CITY OF CARMEL-BY-THE-SEA PLANNING COMMISSION

REGULAR MEETING Wednesday, October 11, 2023

SUBJECT: **DS 23-283 (Minelli):** Consideration of a Design Study, DS 23-283 (Minelli), for a 120-square-foot addition to the lower floor of the residence, demolition of the existing garage, and construction of a new 200-square-foot garage located at Santa Fe Street 3 northeast of Mountain View Avenue located in the Single-Family Residential (R-1) District. This approval is substantially similar to the approval granted by the Planning Commission in June 2020 under Resolution 2020-01-PC; however, the approval has since expired as the approval was never vested. APN: 010-045-014-000.

PROPOSED SITE
PLAN

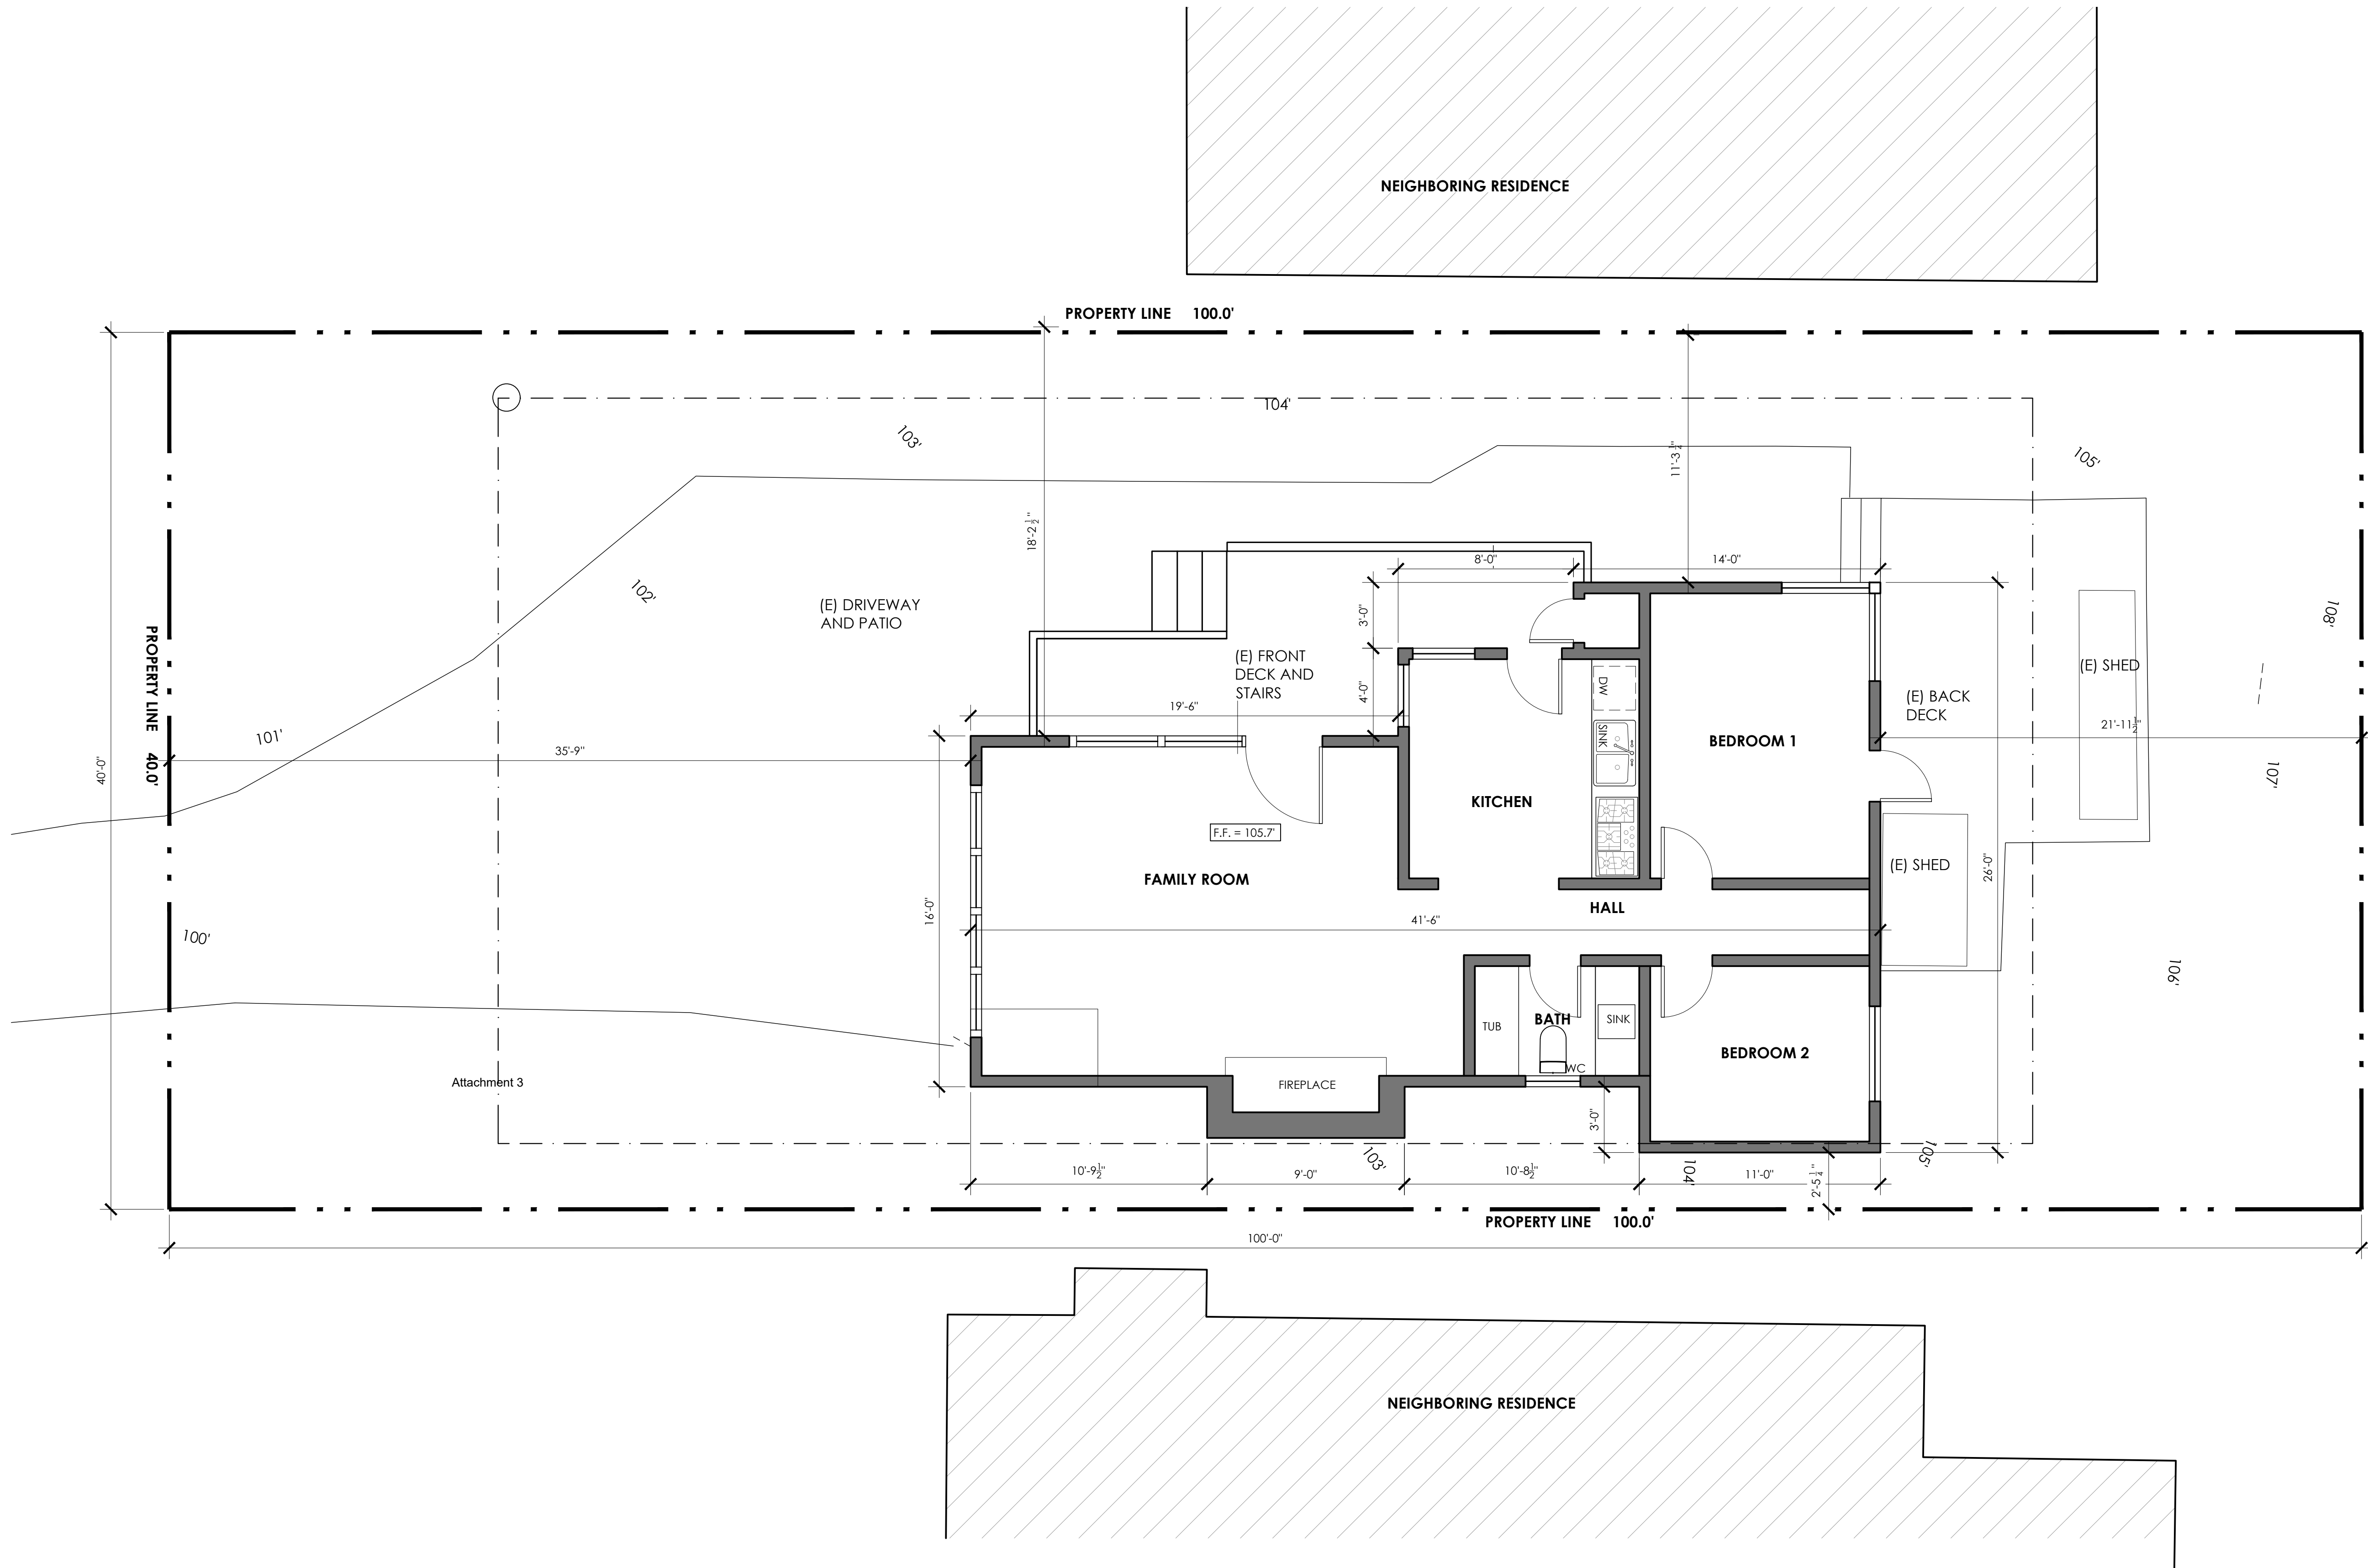
Staff Response: The applicant has updated the existing and proposed site plans (Attachment 1, Sheets A1 and A2) to reflect the structural root zones of existing trees on the property per the City Forester's recommendations. The footprint of the proposed residence is outside of the identified structural root zones in addition to complying with the minimum 6-foot structural setback in CMC 17.48.110.A.3.

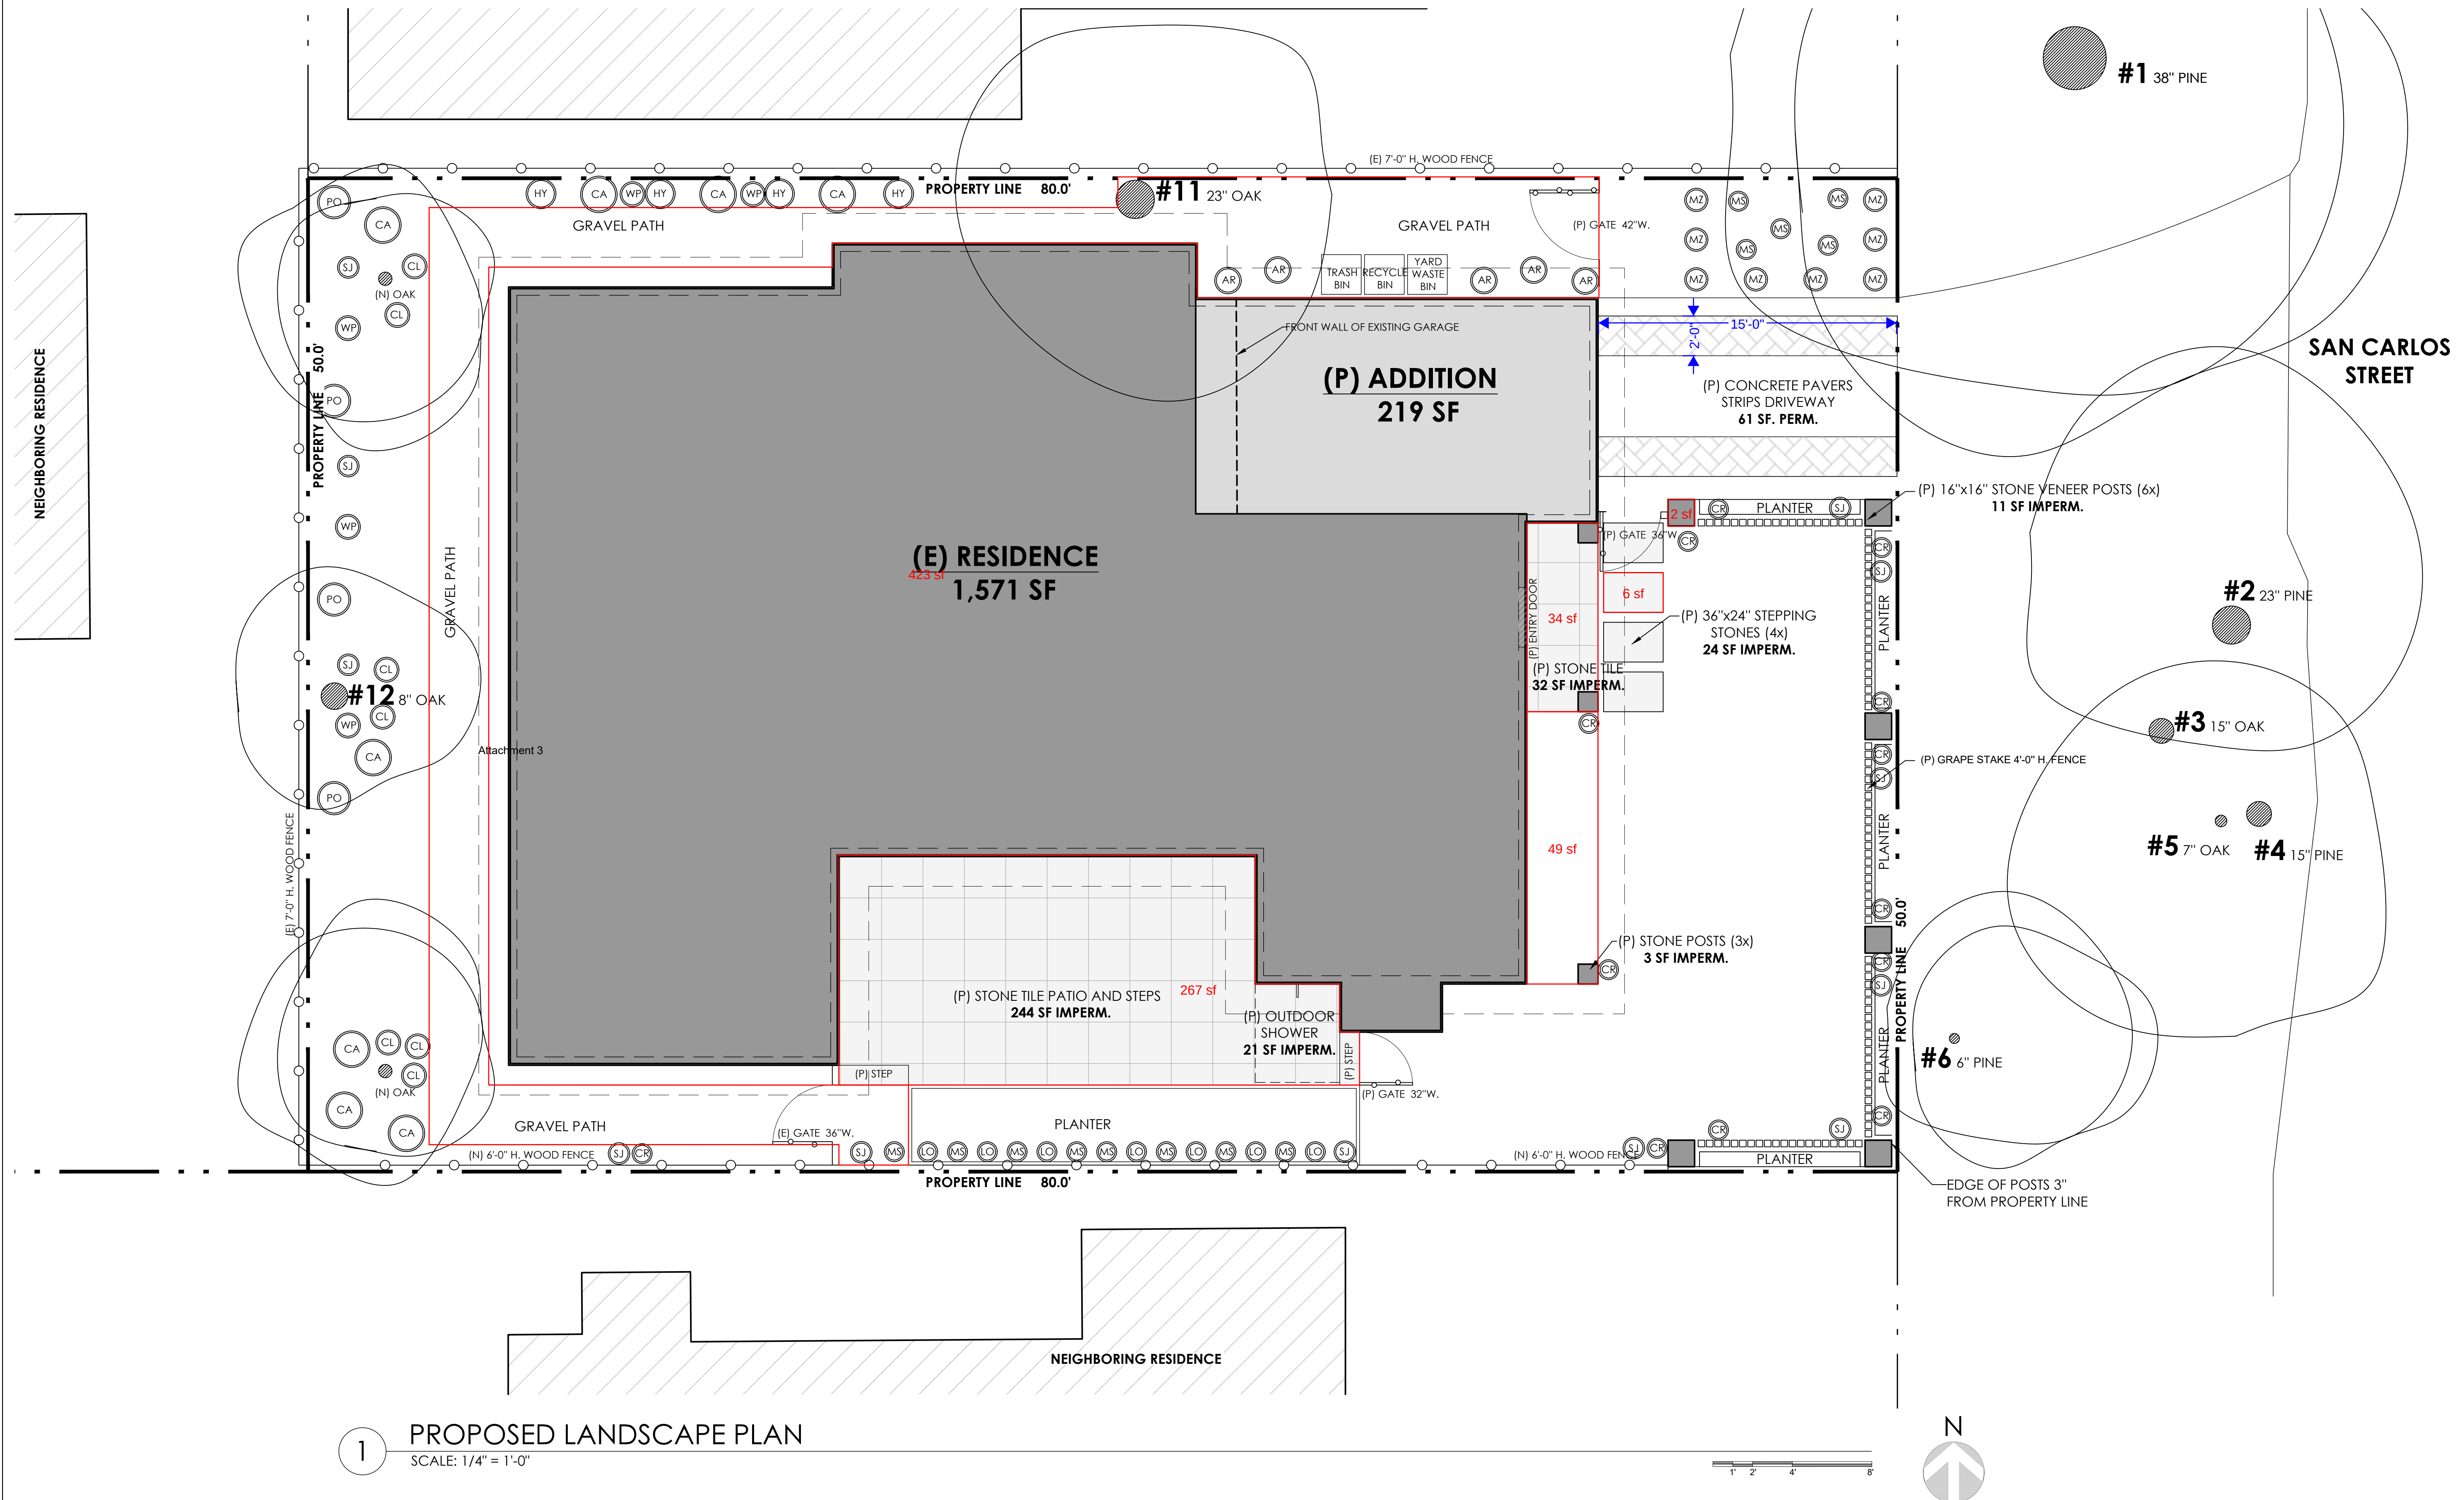
The applicant is proposing to remove all existing site coverage. The proposed site coverage, as depicted on Sheet L 1 (Attachment 3), exceeds what is allowed. The table below summarizes the proposed site coverage. Special Condition No. 40 requires the applicant to submit a revised site plan demonstrating compliance with site coverage standards prior to issuance of a building permit.

Staff Response: The Applicant submitted a preliminary landscape plan (Attachment 3, Sheet L 1). The plan was reviewed by the City Forester and found to be appropriate. Standard Condition No. 22 requires a final landscape and irrigation plan to be submitted for review and approval prior to the issuance of a building permit.
